HISTORIC DISTRICT REVIEW BOARD REGULAR MEETING AGENDA

Agenda Item: HDRB #24-003, to consider an application for a Certificate of Appropriateness for modifications to Town Hall Square outdoor plaza and park adjacent to the Herndon Old Town Hall located at 730 Elden Street, and a portion of the W&OD Trail adjacent to the Herndon Depot.

Agenda Item: HDRB #24-003, Alteration to existing property

June 18, 2024
Historic District Review Board Case # 24-03

Retaining Wall

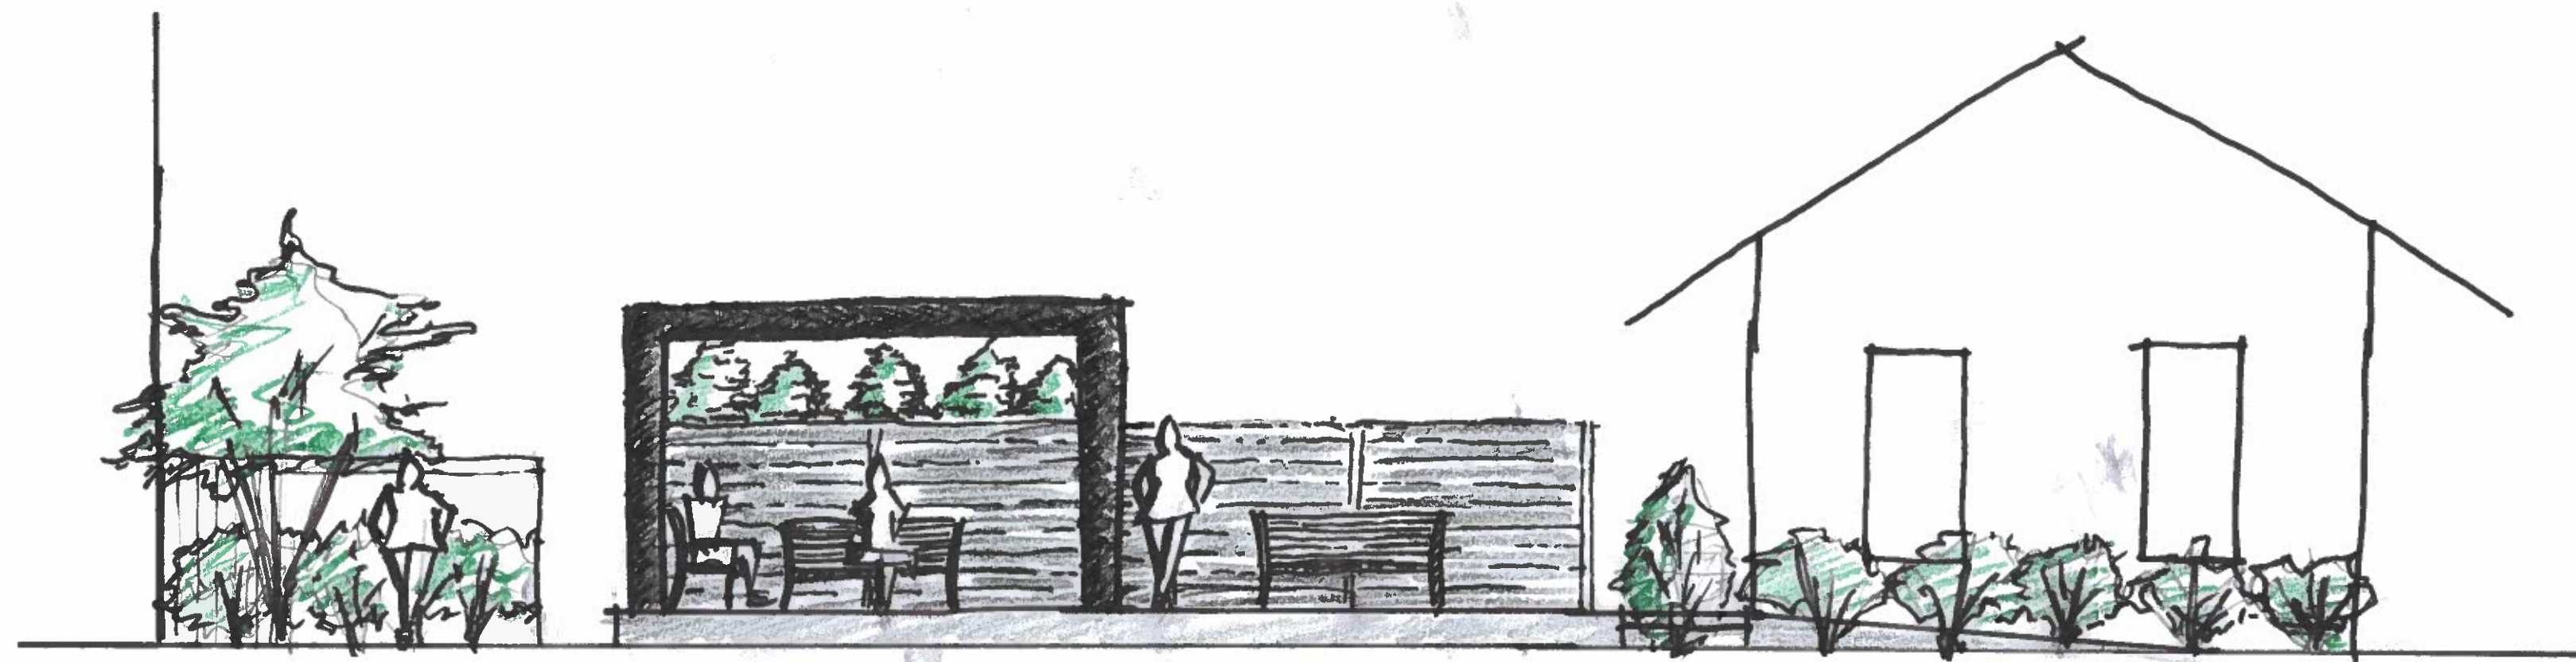
The retaining wall material is now included. The wall is to replace the existing painted timber wall in the same location. This wall will only be visible from the parking lot and partially exposed along the ramp leading to the parking lot on the left side of the deck. A dark grey block was chosen in an effort to hide the wall. This wall is less than 2' tall.
